DOCKETED	
Docket Number:	22-OII-02
Project Title:	Gas Decarbonization
TN #:	271085
Document Title:	Earthjustice Comments - Earthjustice Comments on the California Energy Commission's Draft Staff Report on Clean and Renewable Hydrogen
Description:	N/A
Filer:	System
Organization:	Earthjustice
Submitter Role:	Public
Submission Date:	6/29/2026 4:14:45 PM
Docketed Date:	6/29/2026

**Earthjustice Comments on the California Energy Commission's
Draft Staff Report on Clean and Renewable Hydrogen**

Re: Earthjustice Comments on the California Energy Commission's Draft Staff Report on Clean and Renewable Hydrogen for the Electricity and Transportation Sectors

Figure 7: Relationship between CO₂ emissions from combustion and hydrogen/methane fuel blends (volume %)

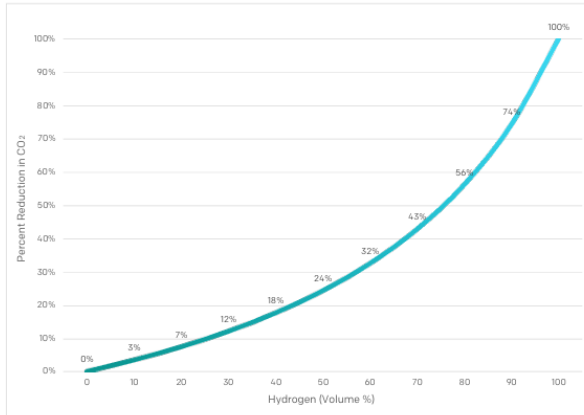
CEC staff should consider including a graph that captures the relationship between carbon dioxide emissions from combustion and hydrogen/methane fuel blends. This type of graphic could be a useful resource for decision makers and the public:²
